WORCESTER COUNTY PLANNING COMMISSION AGENDA

Thursday, February 6, 2025

Approval requested: Step I Residential Planned Community – Establishment of the RPC Floating Zone – Crepe Myrtle Court

Project: Step I Concept Plan –Crepe Myrtle Court Residential Planned Community (RPC).

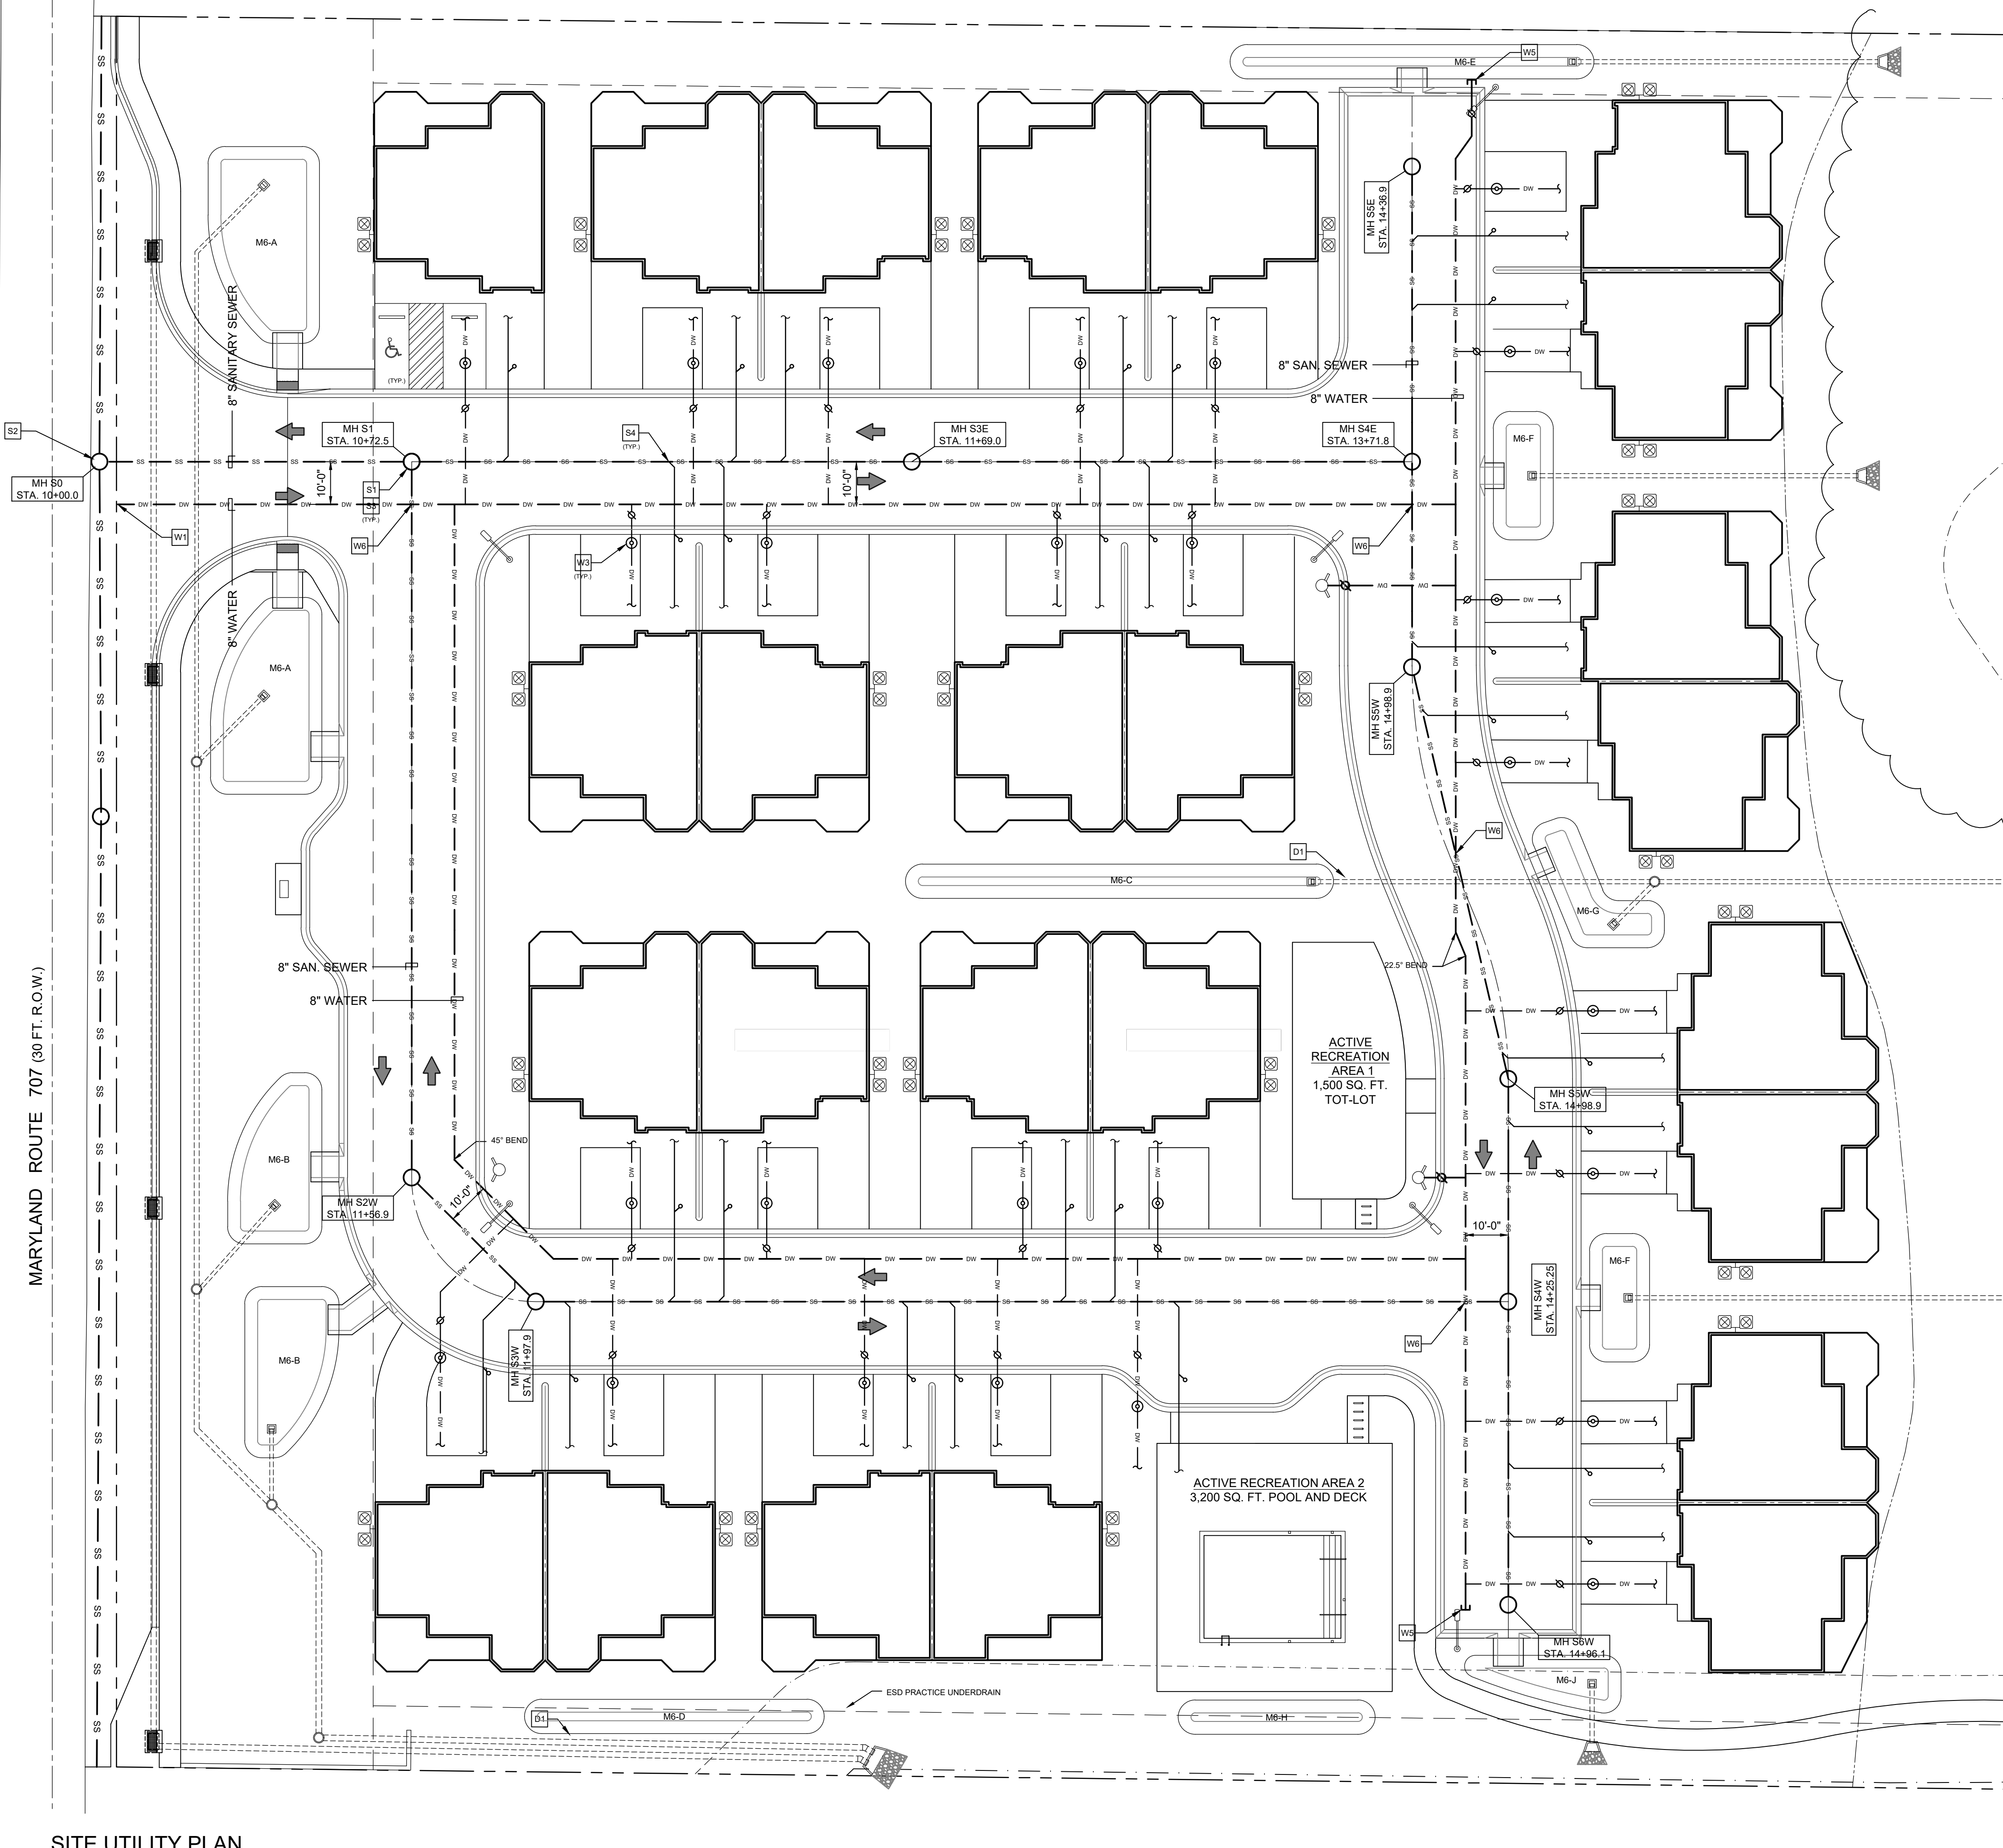
1. On Sheet C-600, Please relocate water meter pits out of the driveways for ease of maintenance.
2. On Sheet C-600, Please show/provide a sprinkler water line and valve details.

3. On Sheet C-600, Please note all water meters are to be at least 1" Neptune T-10 meters with R900i radios with 6' antenna's and procoder registers.
4. On Sheet C-600, Please show detail for manhole doghouse.

5. On Sheet C-600, Please show water valves on 8" water mains at each intersection for isolation.
6. On Sheet C-600, Please show sewer laterals to be 6" to property line cleanout.

7. On Sheet C-600, Please remove sewer line between MH S5W & MH S4W.
8. On Sheet C-600, Hydrant near MH-S2W needs to show connection and valve on plan view.

9. On Sheet C-600, Please eliminate water/sewer crossing near recreation area 1.
10. On Sheet C-600, Please shift light pole and adjust water main near MH – S5E to eliminate additional fittings.

LANDSCAPING PLAN

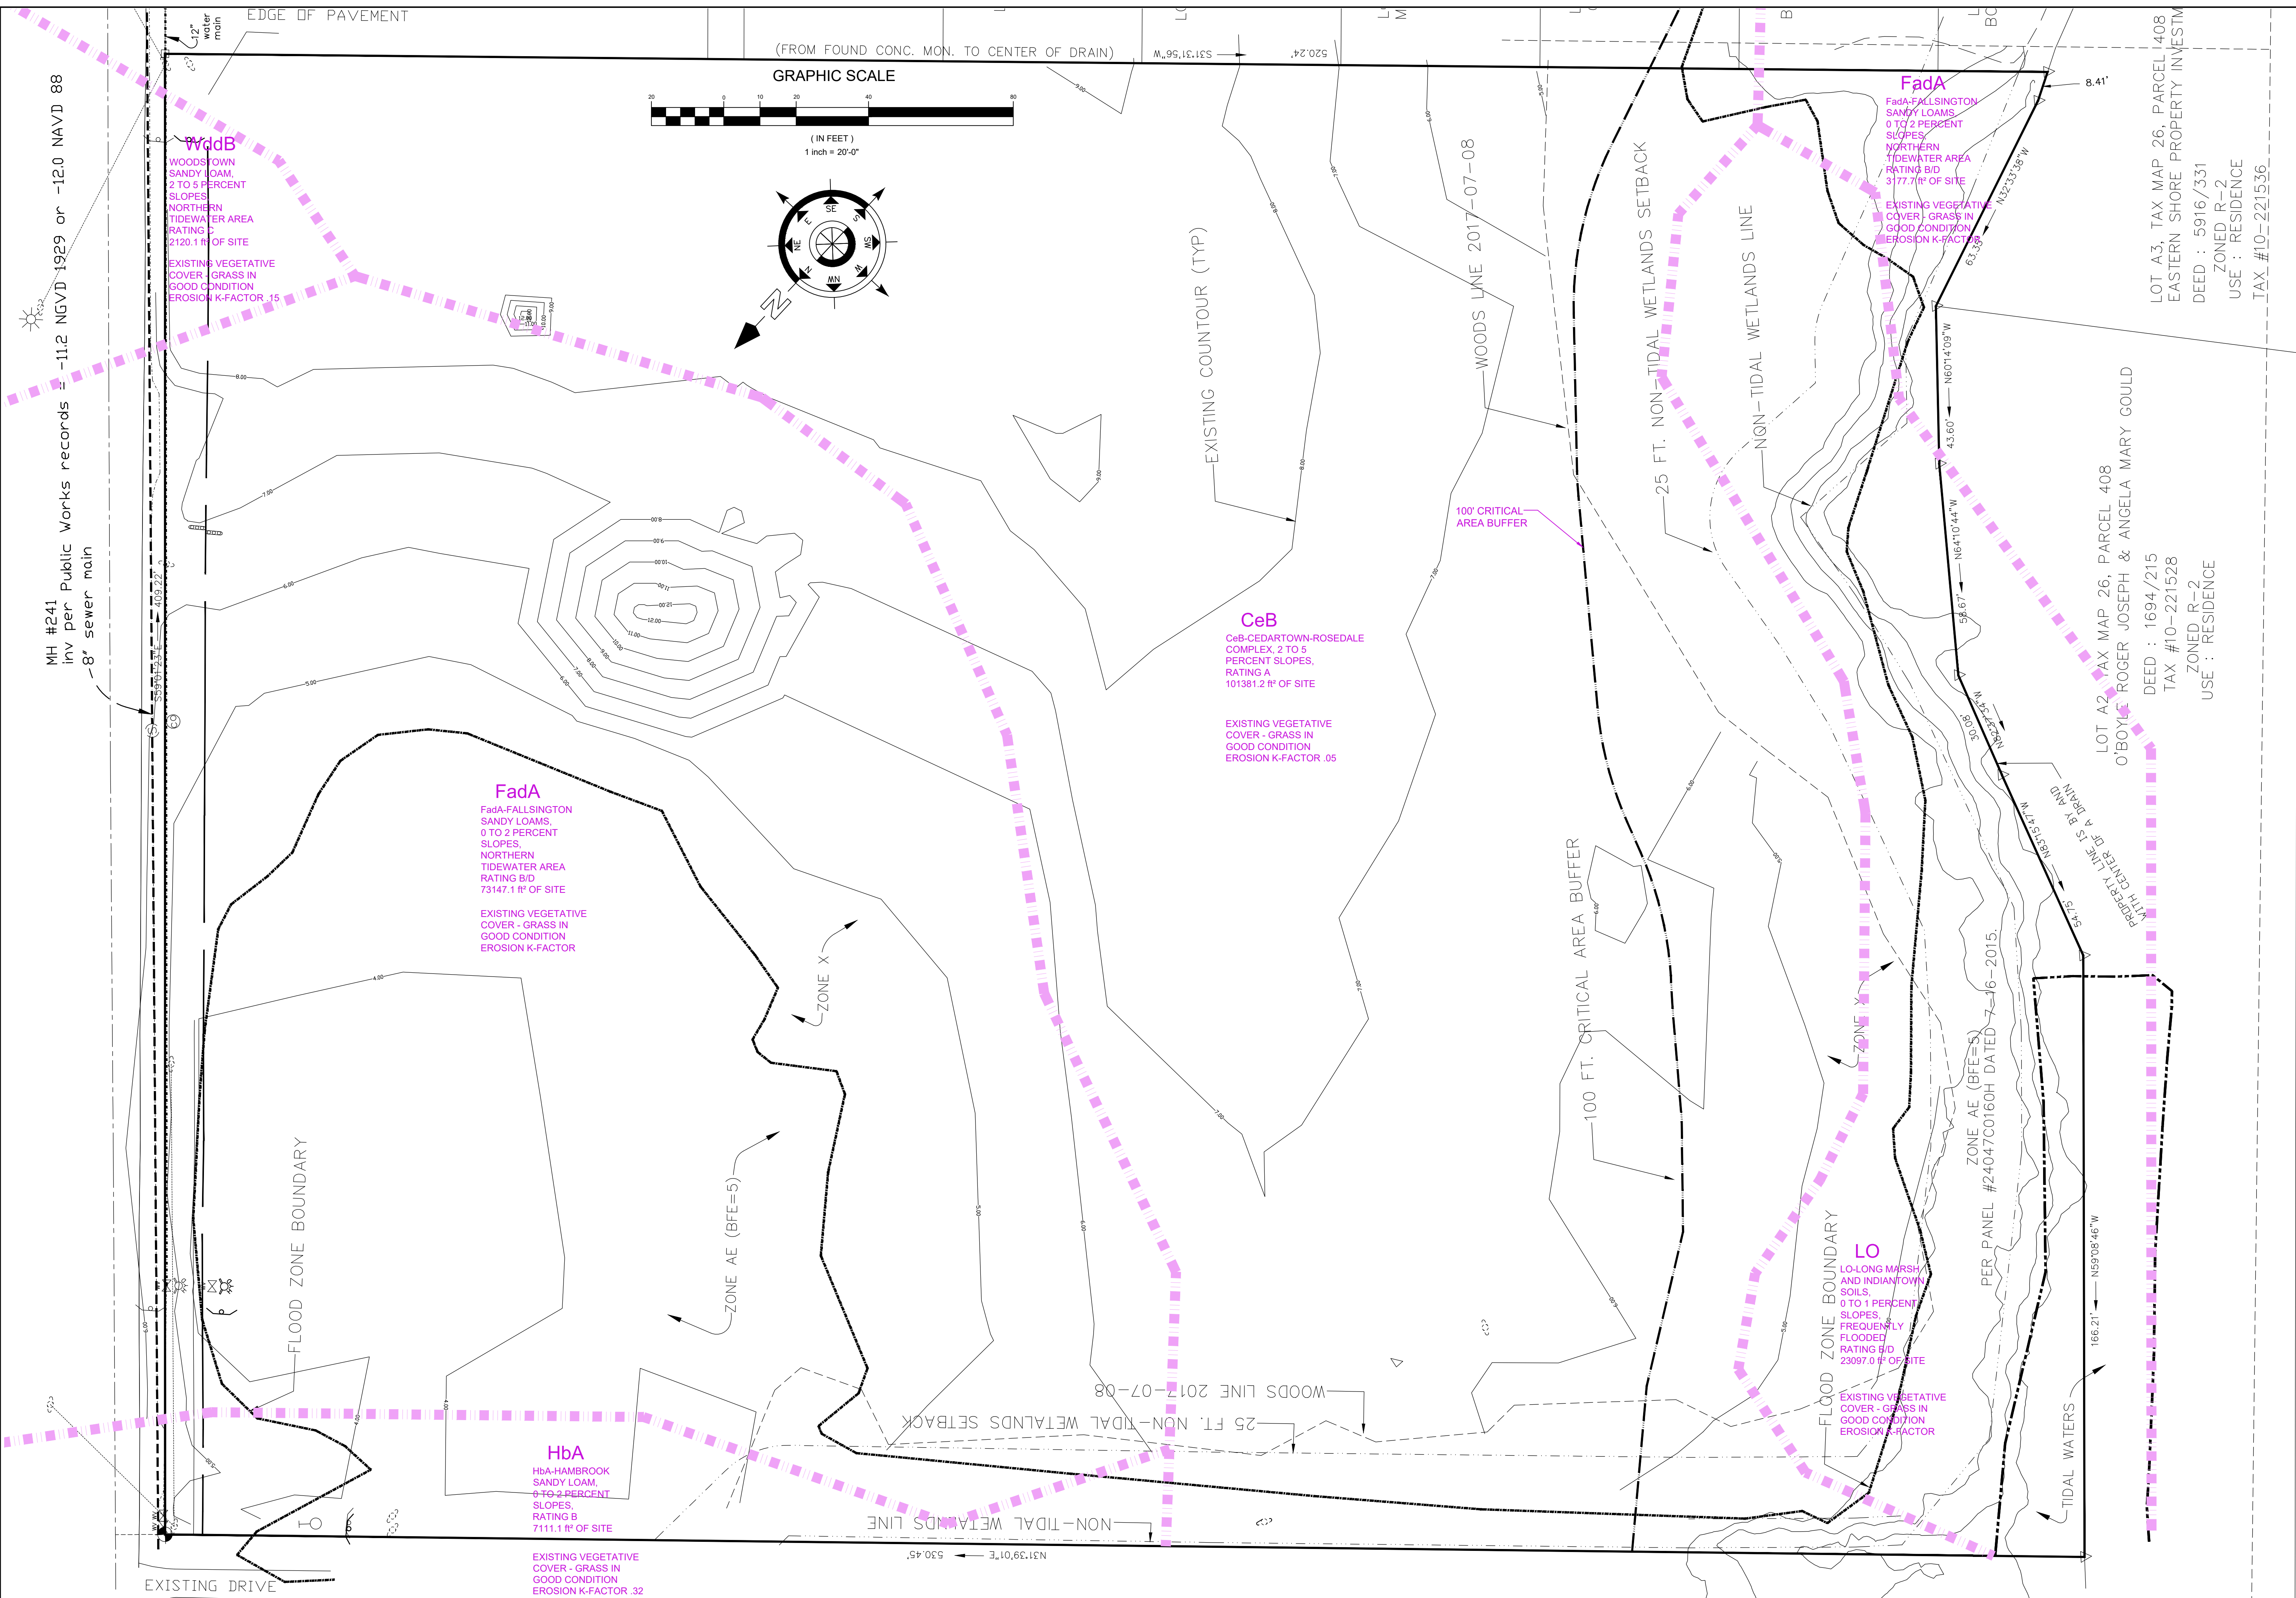
2. Please provide a landscaping plan. "Screening," as defined by the code (<https://ecode360.com/14021103>) will need to be placed along Old Bridge Road as it is considered a collector per §ZS1-322(e)(6). <https://ecode360.com/14021130>

- (7) Please provide a landscaping plan. §ZS1-322(d). <https://ecode360.com/14021093>
- (8) Landscaped screening is required to be installed along Old Bridge Road (MD. Route 707). §ZS1-322(e)(6). <https://ecode360.com/14021130>
